AEP:NRC:3054-08  
10 CFR 2.202

Donald C. Cook Nuclear Plant Unit 1 and Unit 2  
REVISED RESPONSE TO REQUEST FOR ADDITIONAL INFORMATION  
REGARDING RELAXATION OF REACTOR PRESSURE VESSEL HEAD  
PENETRATION INSPECTION REQUIREMENTS IN NUCLEAR  
REGULATORY COMMISSION ORDER

### REVISED RESPONSE TO REQUEST FOR ADDITIONAL INFORMATION

ATTACHMENT 3 TO AEP:NRC:3054-08  
CRACK GROWTH CURVES

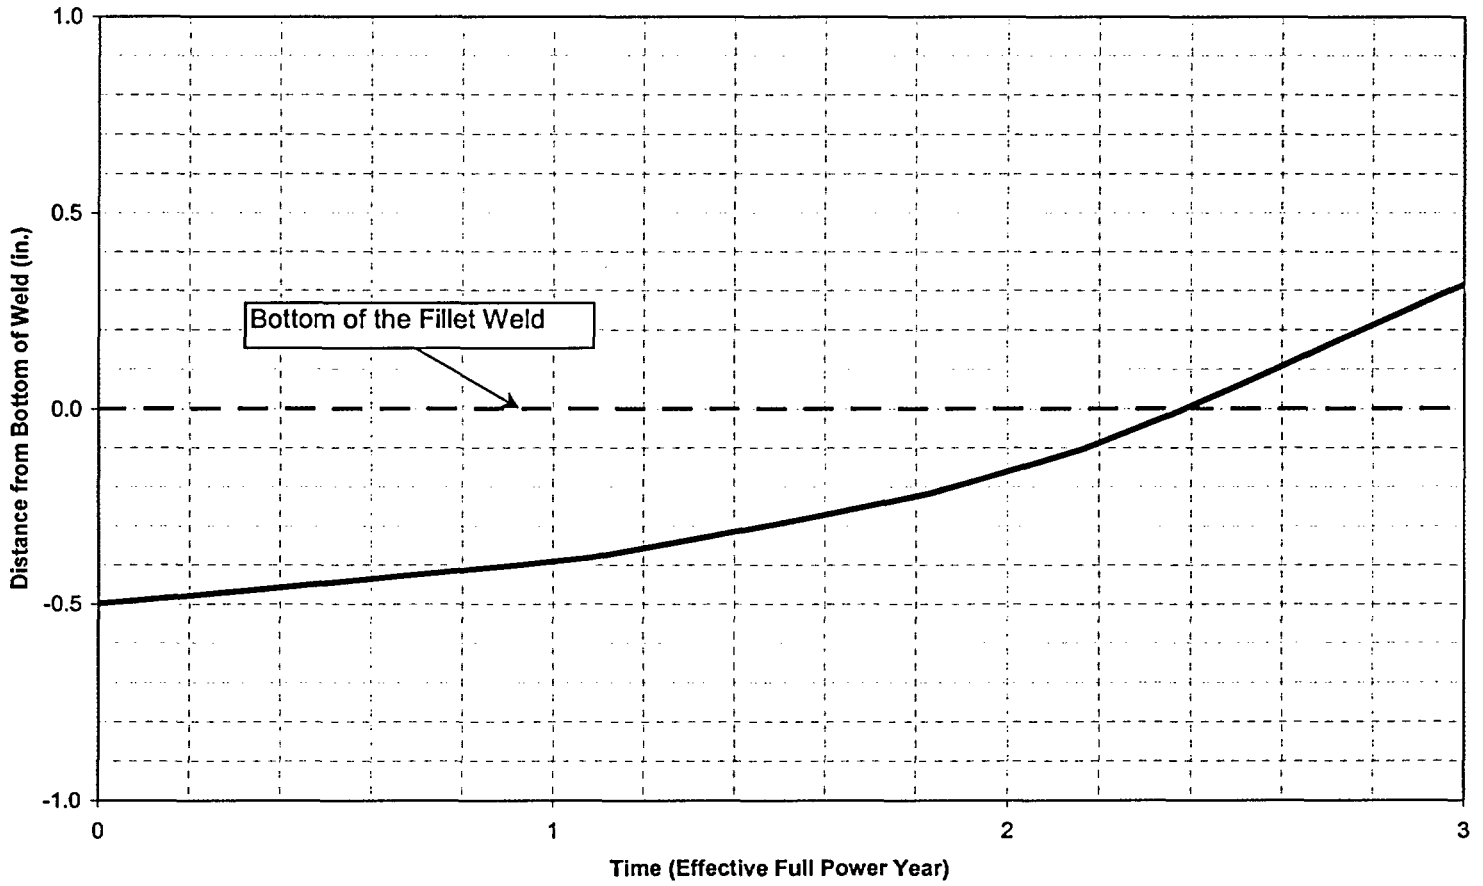
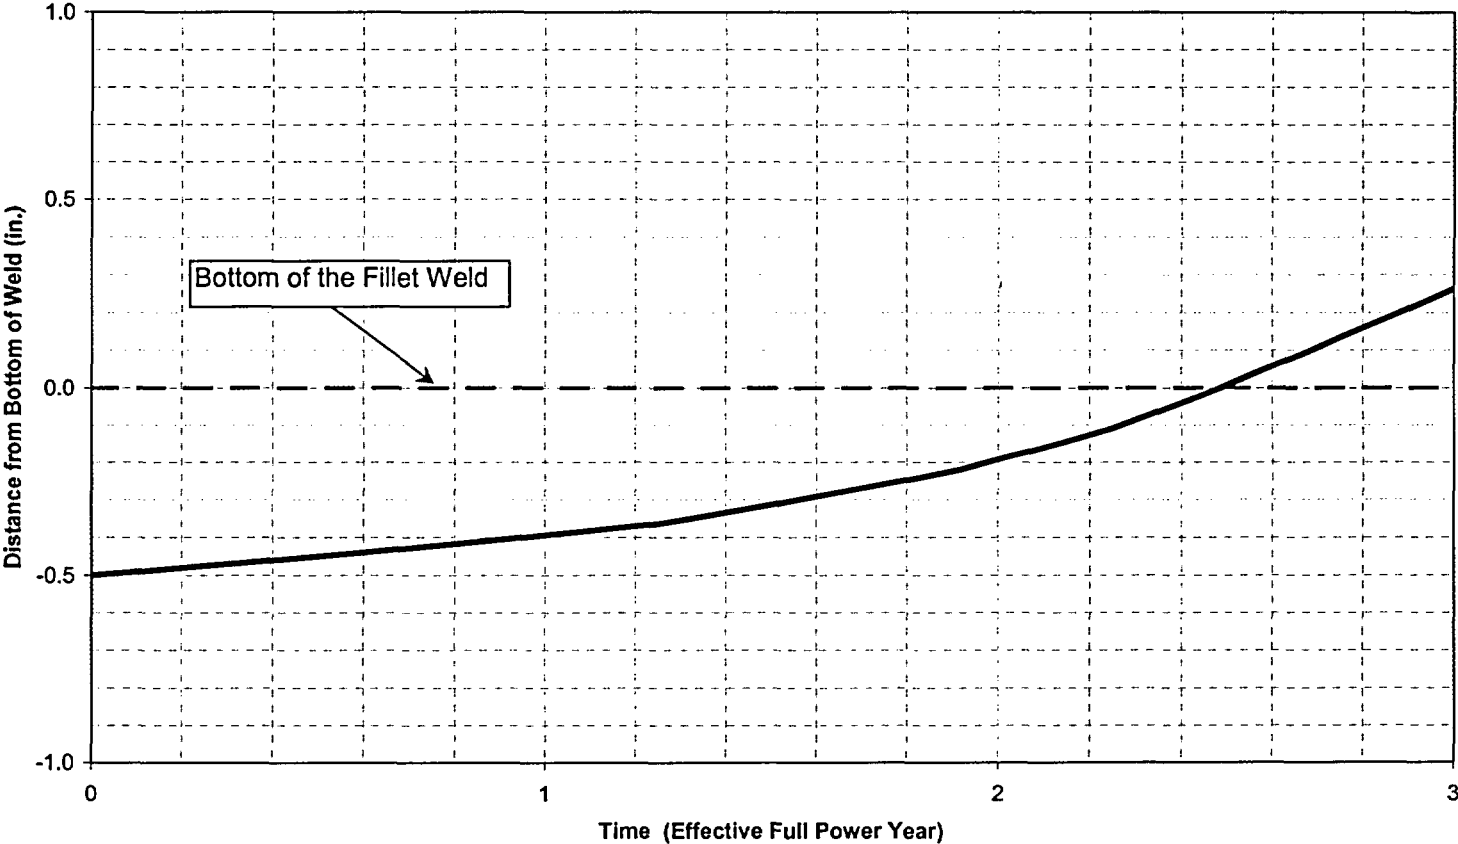
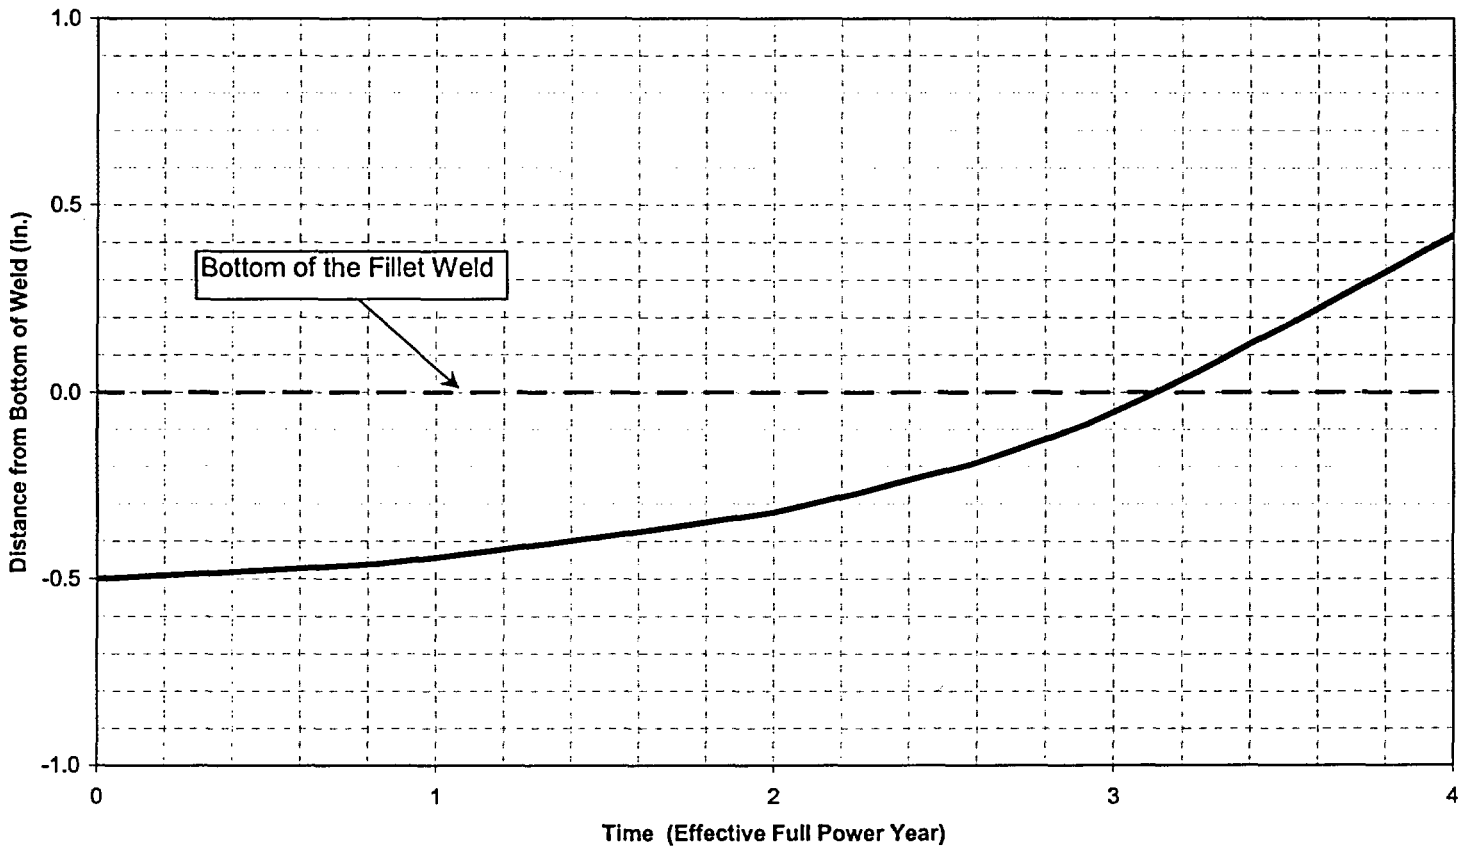
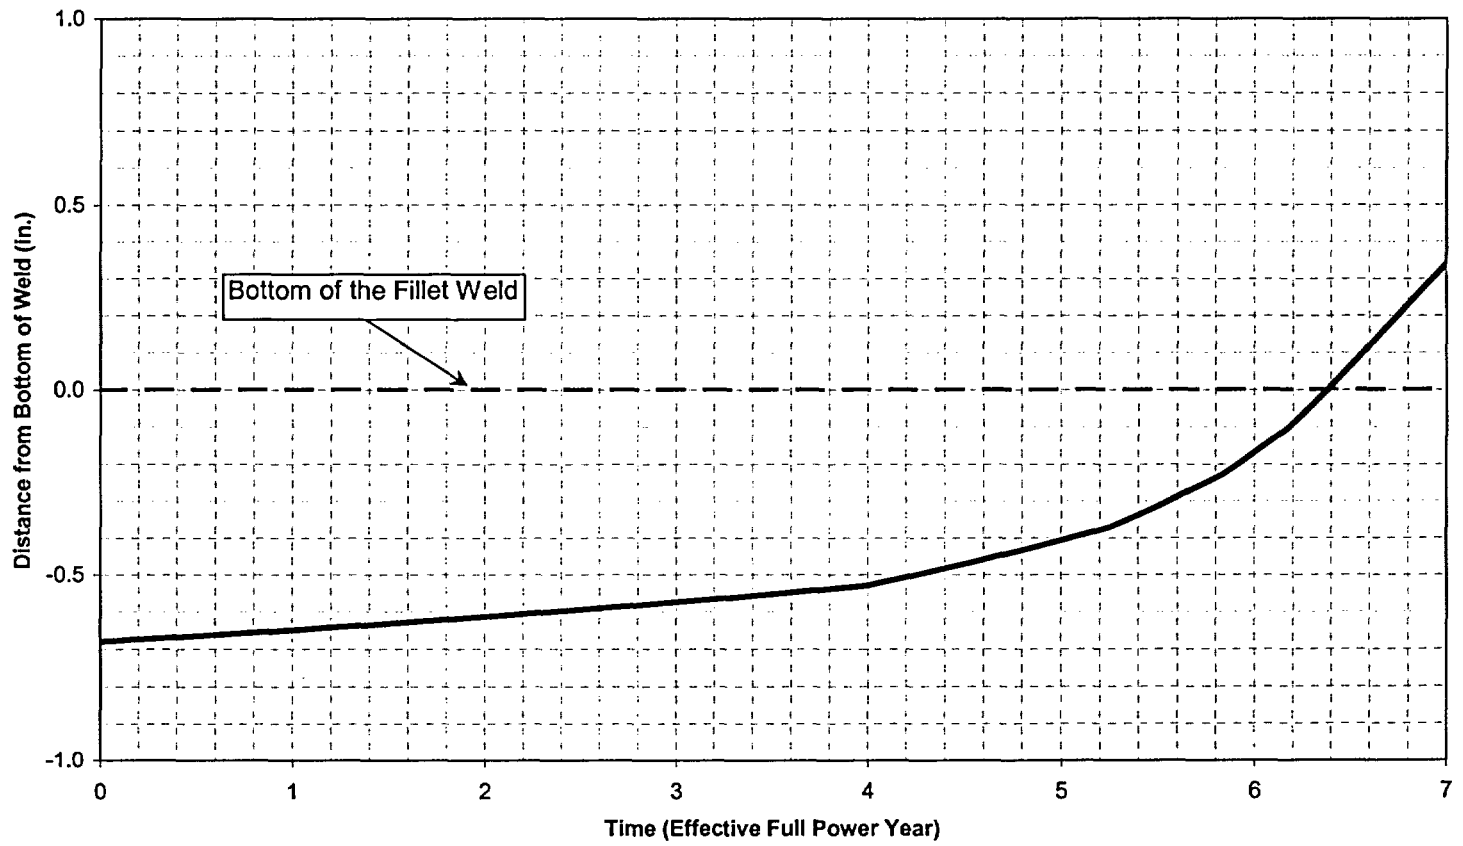
Provide additional technical justification (i.e., operating stress levels, crack growth analysis, etc.) that supports the licensee's statement that the small area that cannot be scanned is insignificant to the phenomena of concern.

Why is the postulated flaw given a depth of 80 percent of the wall thickness instead of 100 percent of the wall thickness? The former does not appear to be conservative.

The calculations were performed for the three outer penetration rows (45.8°, 47.0°, and 50.5° in Attachment 2). The results of these calculations are illustrated by the four crack growth curves provided in Attachment 3 to this letter. The first three curves show that it would take more than 2.3 effective full power years for the postulated flaw 0.5 inches below the J-groove weld to propagate to the bottom of the weld. This time period is more than the minimum under-head inspection interval for Unit 2 (one operating cycle) required by NRC Order EA-03-009. For rows other than the three outer rows, the inspectable length exceeds 1 inch, based on best estimates by personnel reviewing ultrasonic inspection results. The 1 inch inspectable length provides a conservative factor of 2 with respect to the crack growth distance assumed in the calculations. The effect of additional inspectable length on crack growth times is illustrated by a comparison of the first and fourth curves in Attachment 3. These curves show that an increase in inspectable length of 0.18 inches results in an increase of approximately 4 effective full power years in the time it would take a flaw in the uninspectable area to reach the J-groove weld for the third outermost row.

In the crack growth calculation described in Reference 6, the flaw was postulated to be 80 percent through the nozzle wall, since this is the maximum value given in Table A-3320-2 in Appendix A to Section XI of the American Society of Mechanical Engineers Boiler and Pressure Vessel Code. However, a flaw depth of 100 percent was assumed in the above described crack growth calculations.

The one exception occurs on penetration 73. On penetration 73, the minimum distance from the J-groove weld to the threaded area has been determined to be 0.36 inches based on best estimates by personnel reviewing the ultrasonic inspection results. The tolerance on this value is estimated to be plus or minus 10 percent. Since this distance is less than the 0.5 inch value assumed for the location of a postulated flaw in the crack growth calculations described in the response to NRC Question 2, I&M has performed surface examination of the areas below the 0.36 inch distance on penetration 73. The surface examination consisted of eddy current testing of the inside diameter surface down to the top of the chamfer and penetrant testing the threaded surface of the outside diameter down to the bottom of the threads. These surface examinations extended the inspected area beyond 0.5 inches below the J-groove weld. Penetration 73 is in the next to outermost row. The Attachment 3 curve for the next to outermost row shows that it would take a flaw 0.5 inches below the J-groove weld on penetration 73 more than 2.5 effective full power years to propagate to the weld.
